## Global MX-5 Cup Car Technical Service Bulletin #06-27-2017

**REQUIRED:** 2017 Global MX-5 Update: **Cooling hose clamp** update effective immediately

Diagram:

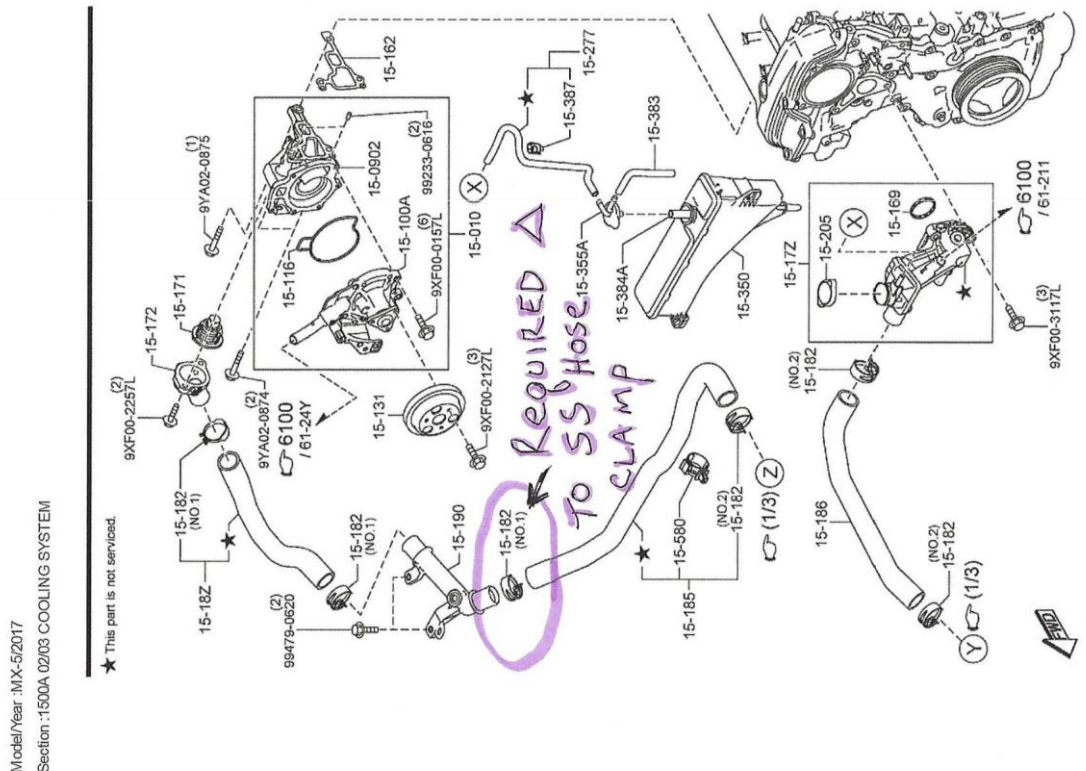
1. A chance of the lower radiator hose clamp may become dislodged (see diagram). The factory spring style clamp is being replaced with a standard stainless steel screw style clamp. **This ONE clamp is a mandatory change**, but all other water hose clamps may be changed to a stainless steel screw style clamps at your option. Purchase the clamp(s) locally.

1. Follow all Mazda service manual instructions for safety, removal and replacement of the water hose clamp(s).
